TOLEDO - LUCAS COUNTY PLAN COMMISSIONS

DATE: September 12, 2022
REF: SUP-7007-22

TO: President Matt Cherry and Members of Council, City of Toledo
FROM: Toledo City Plan Commission, Thomas C. Gibbons, Secretary
SUBJECT: Special Use Permit for a school addition

ELEVATIONS

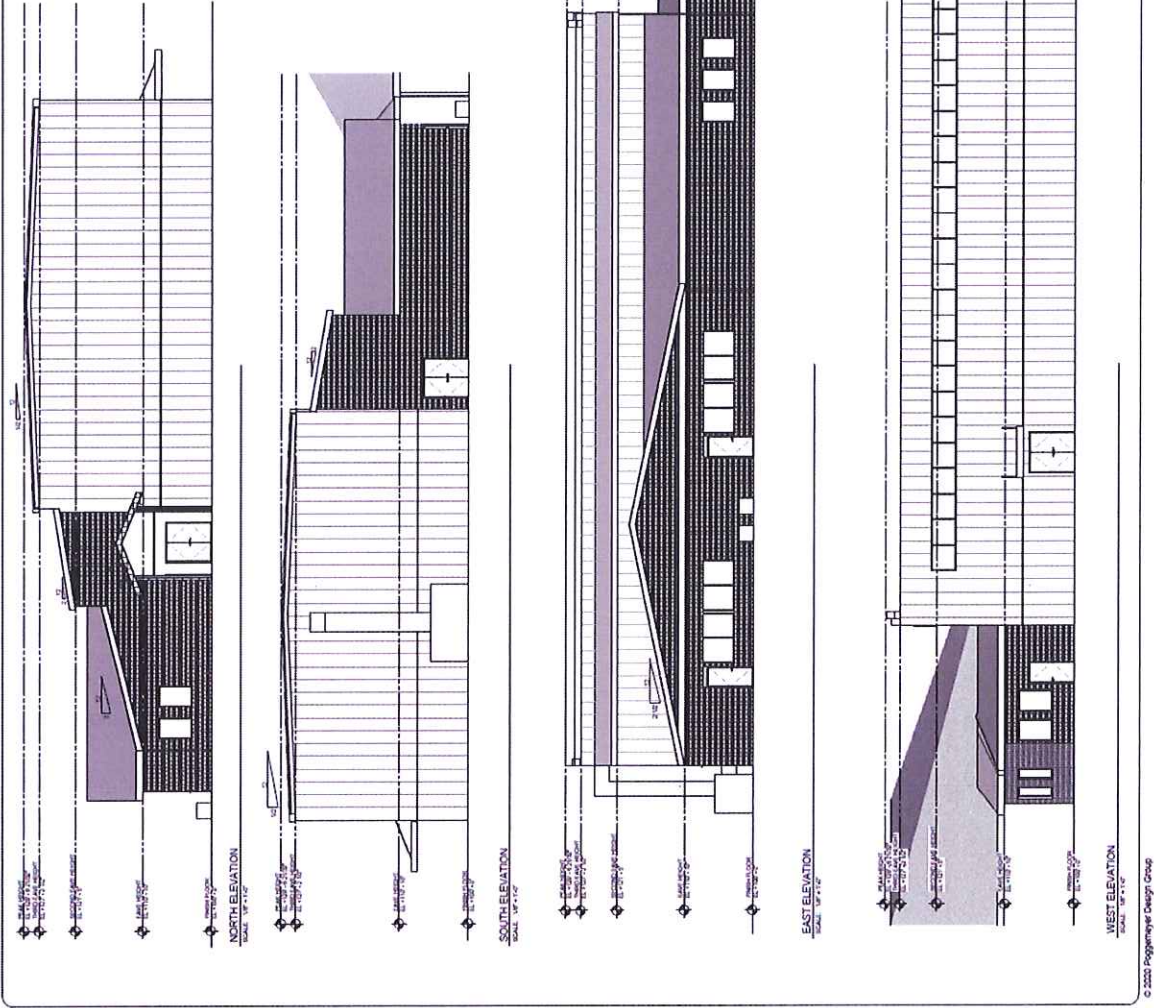
In addition to the building layout, the building materials and colors are reviewed per TMC§1109.0500-*Building Façade Materials and Color*. Predominant materials shall consist of eighty percent (80%) of building facades. The submitted elevations depict brick and windows where the classrooms will be, and architectural metal for the gymnasium. The gymnasium features clerestory windows and a pattern of varying browns, tans, and grays will be featured on the architectural metal panels. The elevations are acceptable as depicted.

29. Building elevations shall be of quality materials as stated in TMC§1109.0500. **Acceptable as depicted.**
30. A detailed site, lighting, fencing and four (4) copies of a landscaping plan (separate from building & site plans) shall be submitted to the Plan Director for review and approval. Such plan shall include:
